## Product Improvement Action No. 987

### Sliding Door Key Cylinder Links

2001 (RS) Chrysler Voyager, Chrysler Town & Country and Dodge Caravan/Grand Caravan

Figure 1

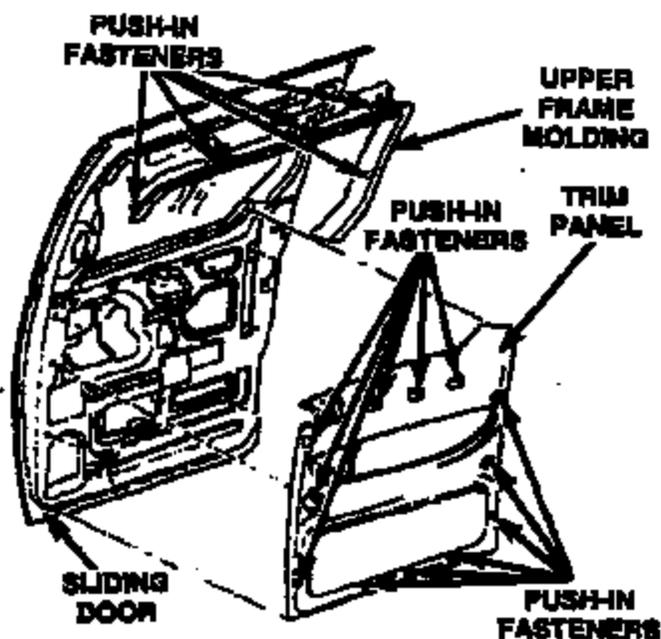
1. Remove the left sliding door upper frame molding (Figure 1).
2. For the LEFT door only: Remove the screw from the inside of the ash receiver bezel.
3. Disengage the push-in fasteners from around the perimeter of the trim panel and then remove the trim panel (Figure 1).

Figure 2

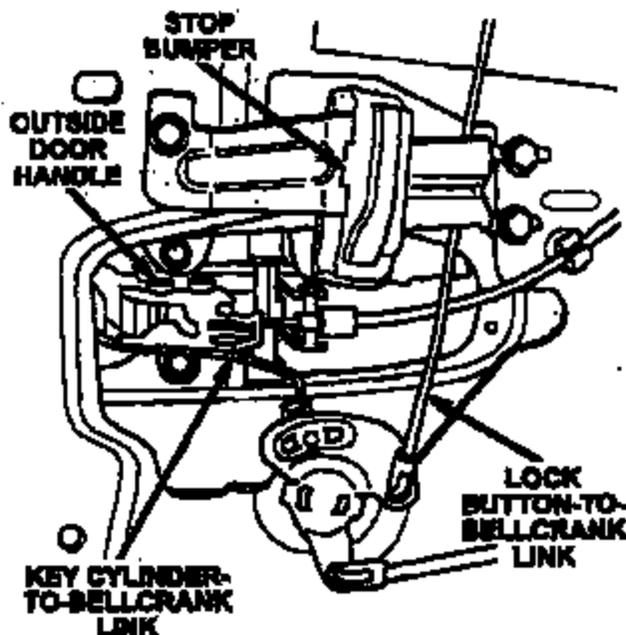
4. Disconnect the key-cylinder-to-bellcrank link from the bellcrank (Figure 2).
5. Remove the three (3) outside door handle nuts.
6. Remove the outside door handle from the door and then disconnect the key-cylinder-to-bellcrank link from the key cylinder (Figure 3). Discard the link.
7. Connect the new link to the key cylinder (Figure 3).
8. Install the outside door handle. Tighten the nuts securely.
9. Connect the key cylinder-to-bellcrank link to the bellcrank (Figure 2).
10. Place the trim panel in position on the sliding door.
11. Engage the locating pins on the backside of the trim panel with the mating holes on the inner door panel (Figure 1).
12. **For the LEFT door only:** Install the screw in the ash receiver.
13. Install the sliding door upper frame molding (Figure 1).
14. Repeat Steps 1-13 for the right side of the vehicle.
